***Development Special Use Permit #2020-10019  
 Coordinated Sign Plan Special Use Permit #2020-00051  
 Transportation Management Plan  
 Special Use Permit #2020-00052  
 Lindsay Company Campus – 1511 North Quaker Lane,  
 1707 Osage Street, and 1525 Kenwood Avenue***

**PLANNING COMMISSION ACTION, JANUARY 5, 2021:** On a motion by Commissioner Koenig, seconded by Commissioner McMahon, the Planning Commission voted to recommend approval of Development Special Use Permit #2020-10019, Coordinated Sign Program Special Use Permit #2020-00051, and Transportation Management Plan Special Use Permit #2020-00052, with the incorporation of the two proposed additional conditions in the applicant letter dated January 5, 2021. The motion carried on a vote of 7 to 0.

LEXUS  
SERVICE FACILITY

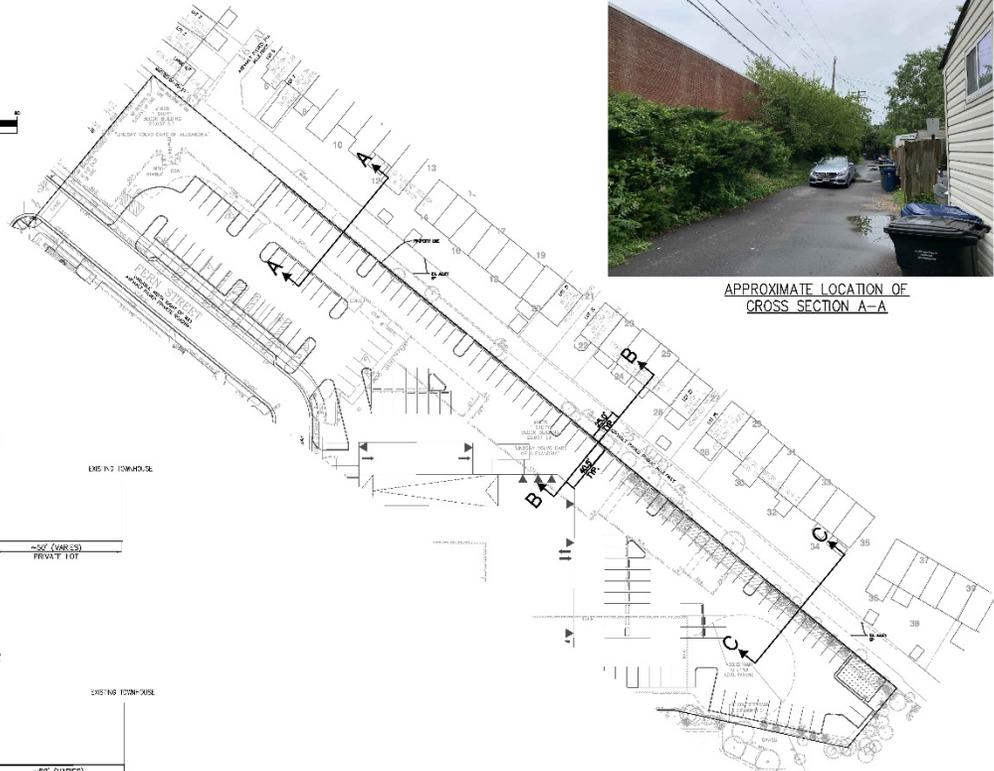
- b. **The Applicant shall increase the height of the fence along the property line from 6’ to 8’ in height. (P&Z) (PC)**
  - c. **The Applicant shall add three trees on Site 2C as reflected on the Exhibit entitled “Site 2B: Additional Planting Exhibit” prepared by Parker Rodriguez Inc. and dated January 4, 2021. (P&Z) (PC)**
